Public Service Electric and Gas Company 80 Park Place Newark, N.J. 07101 Phone 201/430-7000

January 18, 1979

RESPONSE TO REQUESTS FOR
ADDITIONAL INFORMATION
NO. 2 UNIT
SALEM NUCLEAR GENERATING STATION
DOCKET NO. 50-311

Public Service Electric and Gas Company hereby transmits sixty (60) copies of its responses to certain of your requests for additional information to NRC Questions 4.38, 5.96, 5.110, 13.9 (preoperational testing), Quality Assurance and Sub-compartment Analysis. The information contained herein will be incorporated into the Salem FSAR in an amendment to our application.

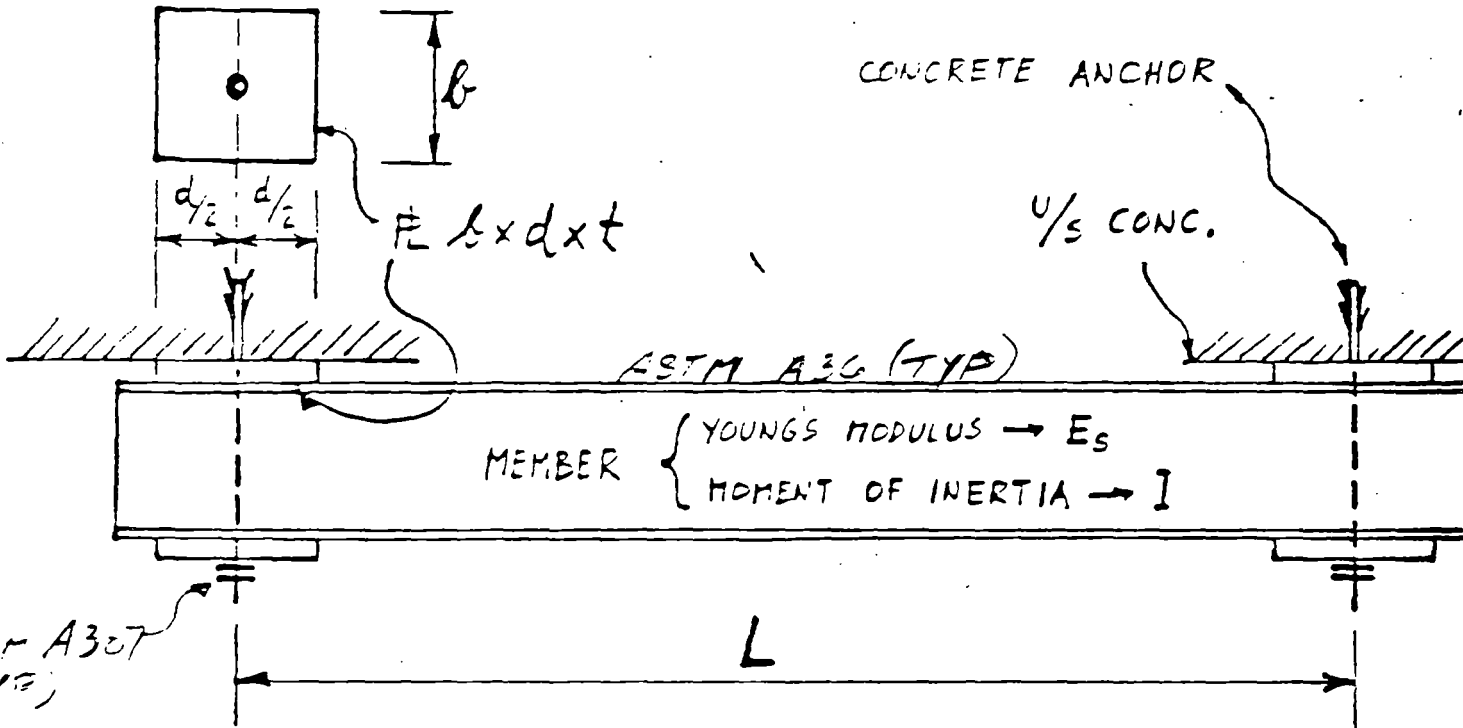
Appendix XVII-2461 of the ASME Code Section III requires that bolt loads in bolted connections for linear component supports include prying effects due to the flexibility of the connection.

(1) Provide confirmation that the loads in bolted connections for linear component supports were determined by considering the deformation of the connection and tension-shear interaction for the bolts. For connections of supports which are anchored to a concrete structures provide in addition:

- a. The type of anchor bolt
- b. The factors of safety (and their bases) against pullout under static, repeated and transient loading.

This information should include representatives diagrams of the connections, material properties and interaction diagrams, the analytical techniques and models used, and the maximum stresses in the bolts and the connections under both static, repeated, and transient type loading.

(2) If any connection was assumed to be rigid, provide complete analytical or experimental justification for this assumption.

(1) In developing designs for bolted component supports for piping, tension and shear interactions were considered. The design conservatism on structural members is considered sufficient such that deformation of the connection does not adversely affect the capacity of connections to withstand design loadings.

a. Types of anchor bolts used for the various bolted connections in the plant are as follows:

- (1) The majority of safety related supports employ connections bolted to concrete inserts which derive their strength from an integral steel

coil embedded in the concrete at the time of structure forming.

(2) The other type of anchor bolt used employs an expandable wedge piece inserted in a pre-bored hole in the concrete.
